FROM: Toledo Edison Co Toledo, Ohio L E Roe		DATE OF DOC 1-8-76	DATE REC'D 1-13-76	LTR XX	TWX	RPT	OTHER
TO: Mr Schwencer		ORIG one signed	CC	OTHER	SENT NRC PDR	X:	
					SENT LOCAL PDR	XX	
CLASS	UNCLASS XXX	PROP INFO	INPUT	NO CYS REC'D 1	DOCKET NO: 50-346		
DESCRIPTION: Ltr re our 11-14-76.....trans the following:				ENCLOSURES: Info concerning ECCS Sump testing.....			
PLANT NAME: Davis Besse #1

Enclosed is the information regarding the Davis-Besse Nuclear Power Station Unit 1 pertaining to ECCS sump testing as requested in your letter of November 14, 1975.

RESPONSES TO NRC LETTER ON ECCS SUMP

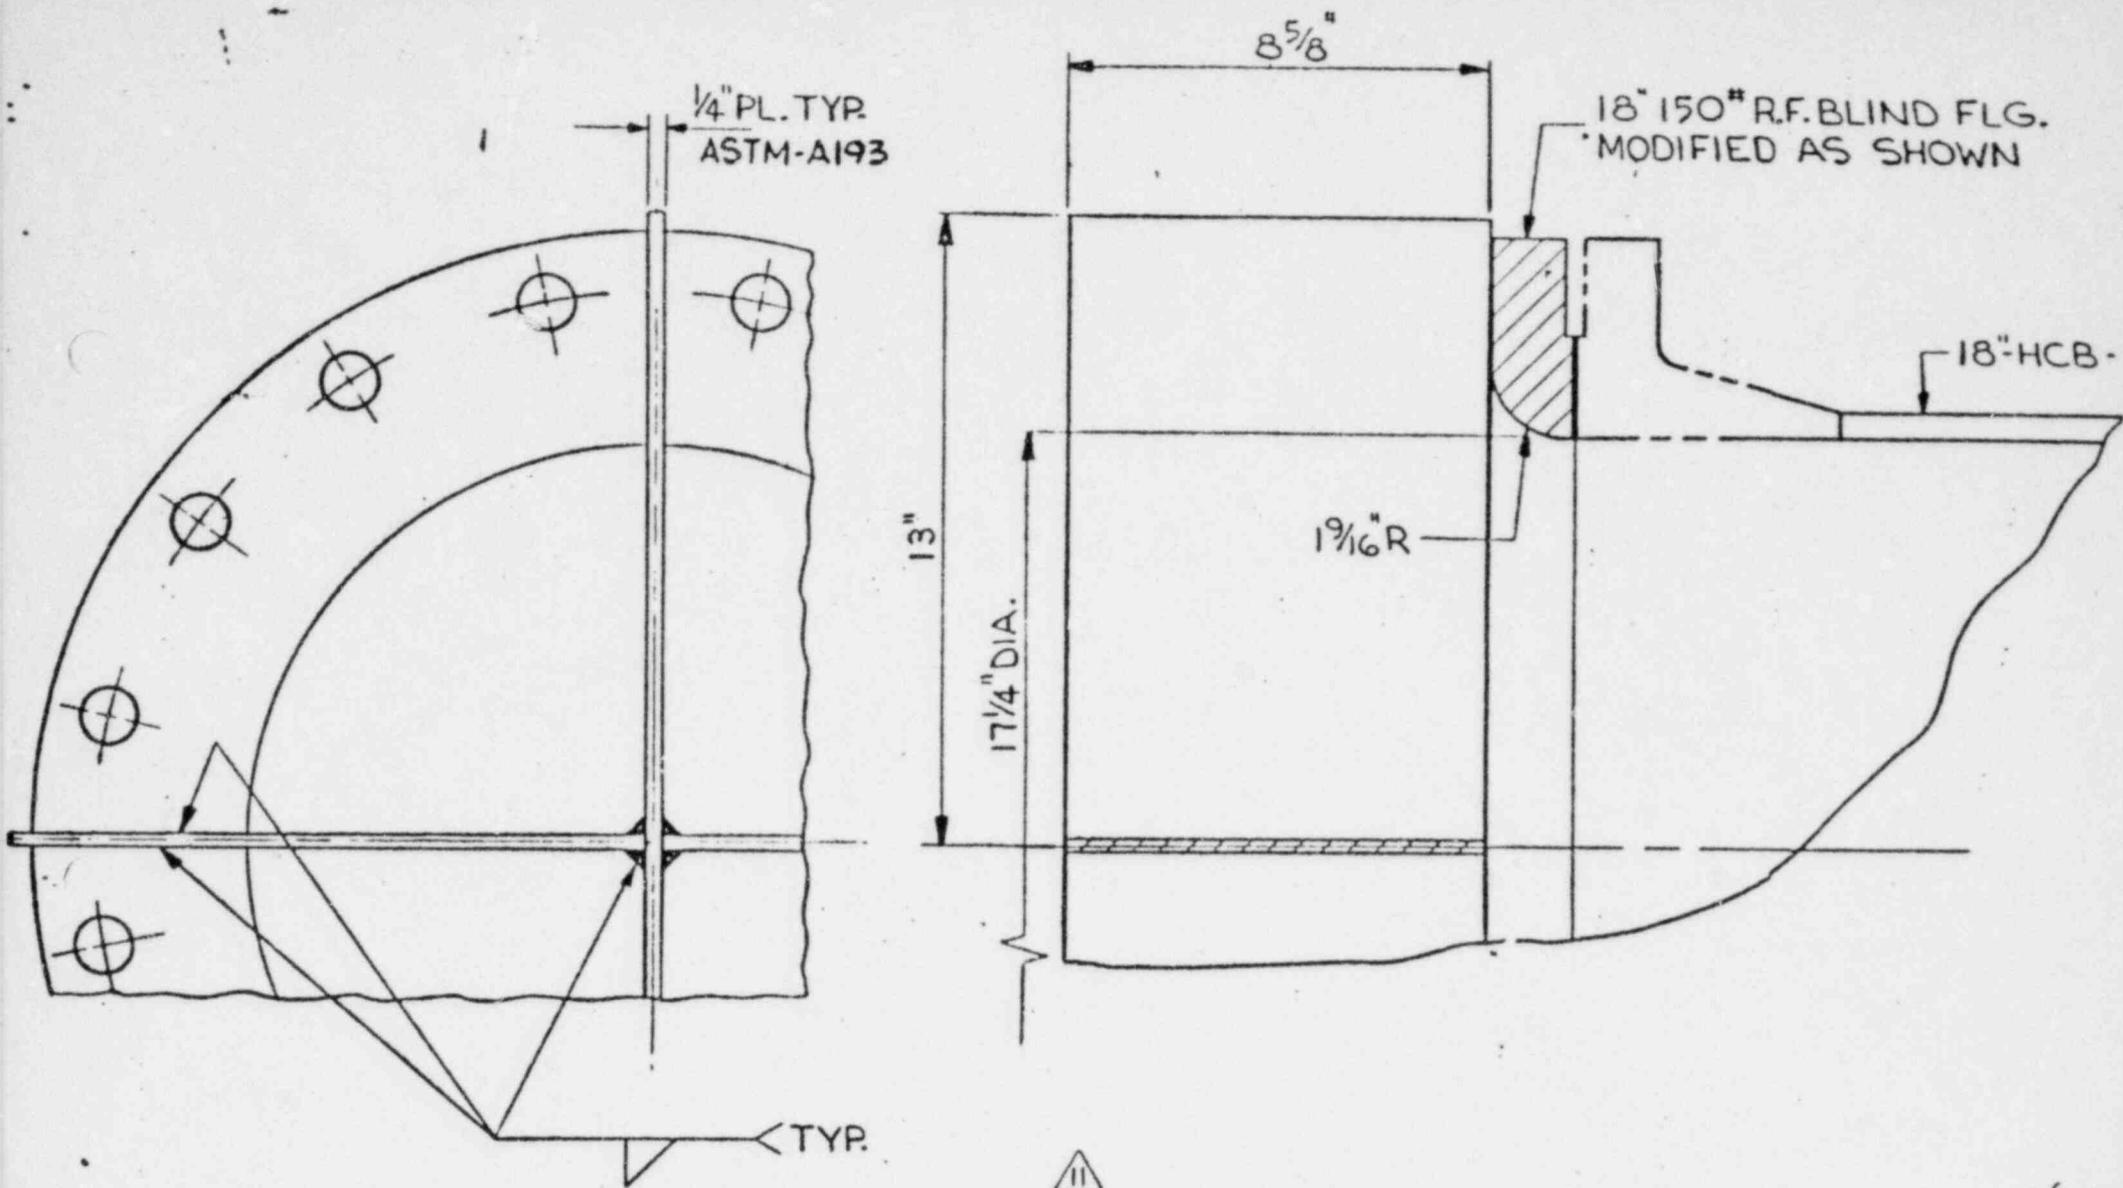
3. The NPSH required for the containment spray pumps was tested by the manufacturer in accordance with the Hydraulics Institute Standards. The test was performed by throttling a valve in the suction line of the test apparatus while holding the flow rate constant at the design value of 1300 gpm. In accordance with the referenced standard, a 3% drop in pump head was used to indicate the onset of cavitation. Using the point thus obtained, the remainder of the NPSH required VS flow rate curve was extrapolated based on the extensive test and operating data accumulated for the pump model. From this curve the NPSH required for the containment spray pump at 1500 gpm is 11 feet.
